**HUGHES
SERVICE INFORMATION
NOTICE**

NOTICE NO. N-154

**SUBJECT: FIELD MODIFICATION TO NEW 4-BOLT ATTACHMENT
CONFIGURATION - TAIL SKID TUBE, TAIL BOOM ADAPTER
AND TRANSMISSION HOUSING**

**MODELS AFFECTED: All Model 269A, TH-55A, 269A-1 and 269B Helicopters;
Model 269C Helicopter Serial No. 0004 thru 0687**

Figure 1. Rework of Tail Boom Adapter or Transmission Housing

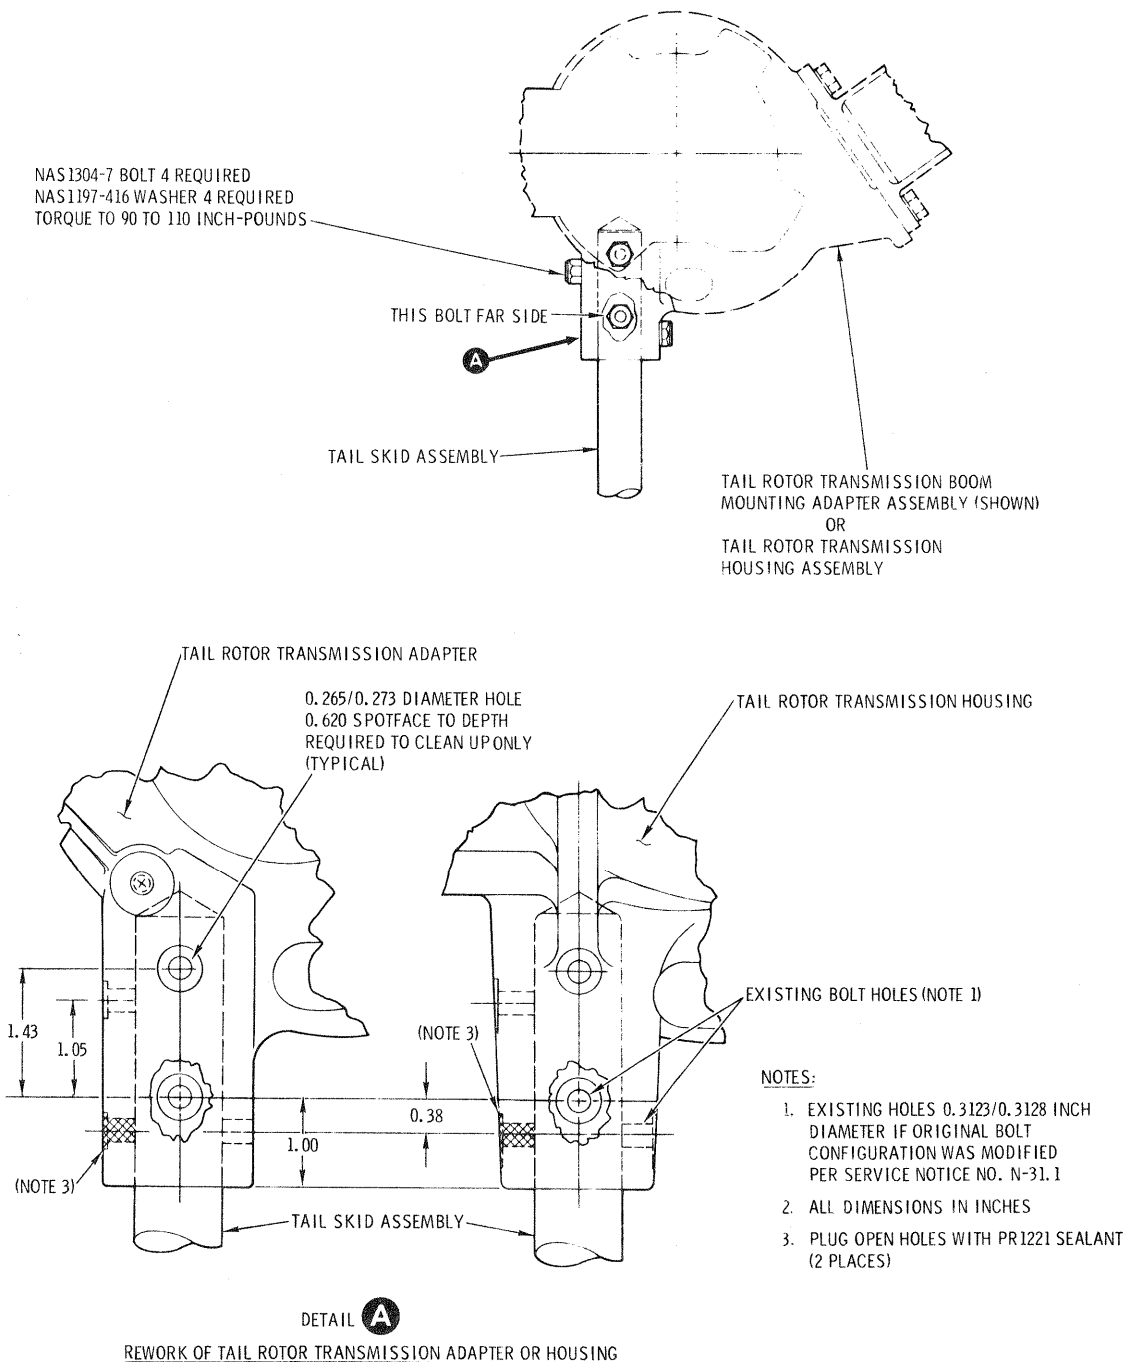
- a. Remove existing dual bolt mounting hardware securing tail skid assembly; remove tail skid assembly.
- b. Drill 0.265/0.273 inch diameter hole through one wall on adapter or transmission housing, two additional places 90° to each other, per dimensions shown in Figure 1, to match additional nutplate locations on new PN 269A2305-9 or -11 tail skid assembly.

- c. Using spotface tool, spotface 0.620 inch diameter to depth required to clean up 0.500 inch wide surface, two places at new hole locations as shown.

- d. Touch up reworked areas with corrosion preventative coating.
- e. Install new PN 269A2305-9 or -11 tail skid assembly, as applicable, using four NAS1304-7 bolts and NAS1197-416 washers. Apply wet zinc chromate primer to bolts prior to installation.

- f. Torque bolts to 90 to 110 inch-pounds.
- g. Plug remaining open holes, two places, with sealant.
- h. Check field rework and installation of tail skid for discrepancies.

Figure 2. Rework of PN 269A2305 or 269A2305-5 Tail Skid Assembly

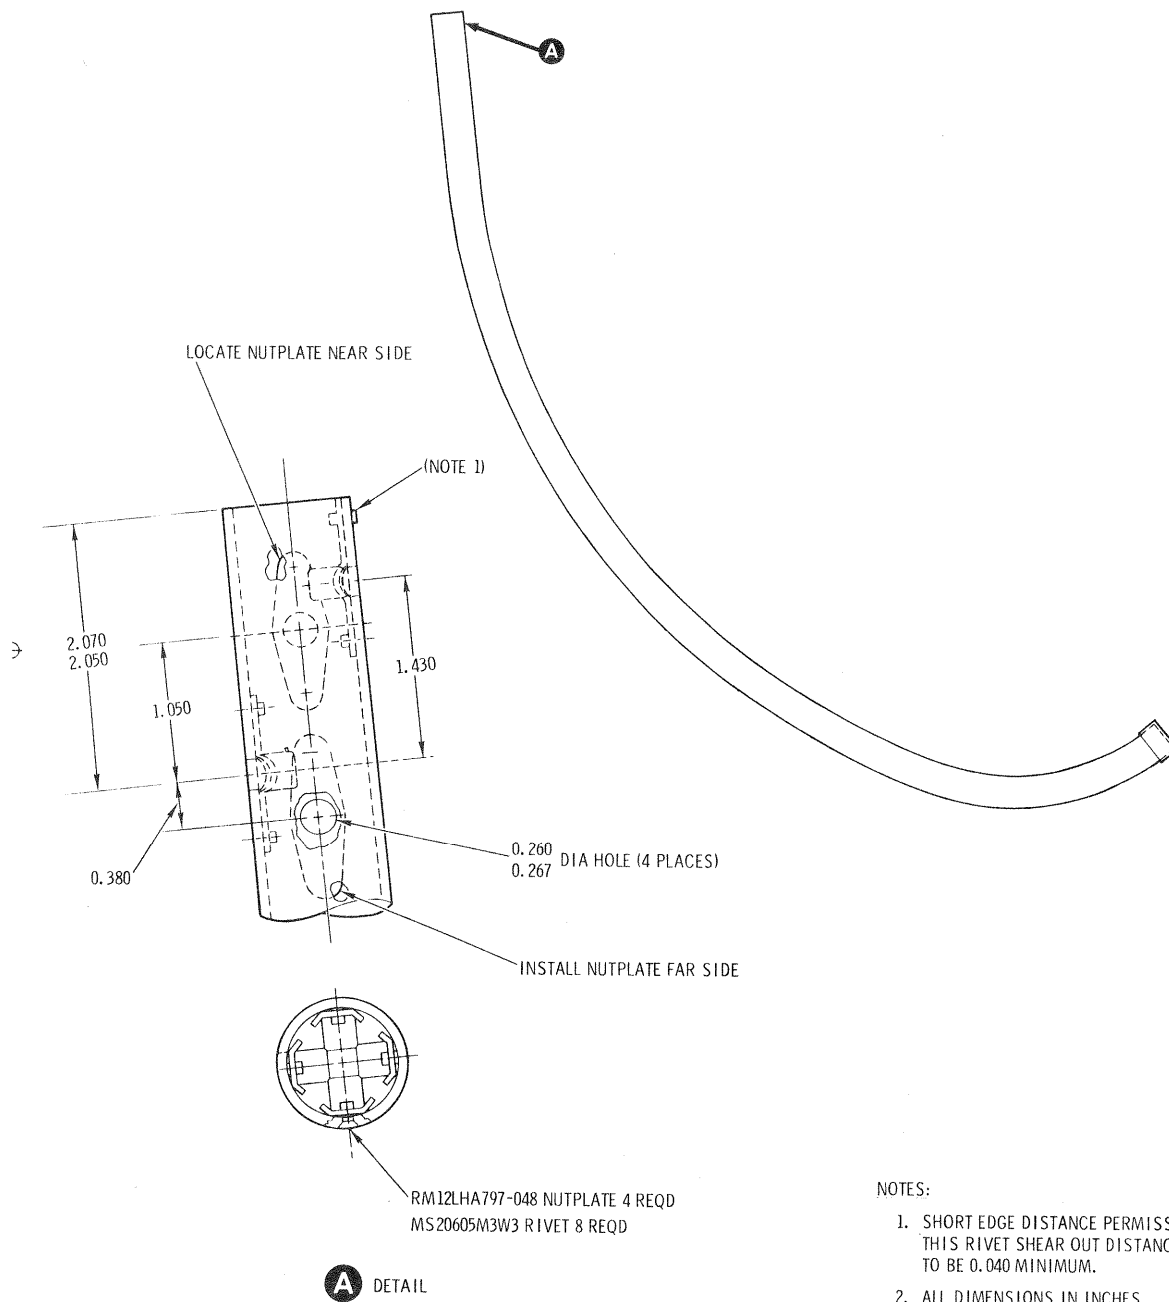
b. Drill 0.260/0.267 inch diameter hole through one wall on tail skid, two additional places 90° to each other, per dimensions shown in Figure 2, to match additional attachment holes in adapter or transmission housing.

d. Mark and drill two 0.096 inch diameter rivet holes at each of the four attachment holes, as shown.

e. Install nutplates, four places, with rivets; install rivets with zinc chromate primer.

f. Install reworked tail skid assembly, using four NAS1304-7 bolts and NAS1197-416 washers. Apply wet zinc chromate primer to bolts prior to installation.

g. Torque bolts to 90 to 110 inch-pounds.
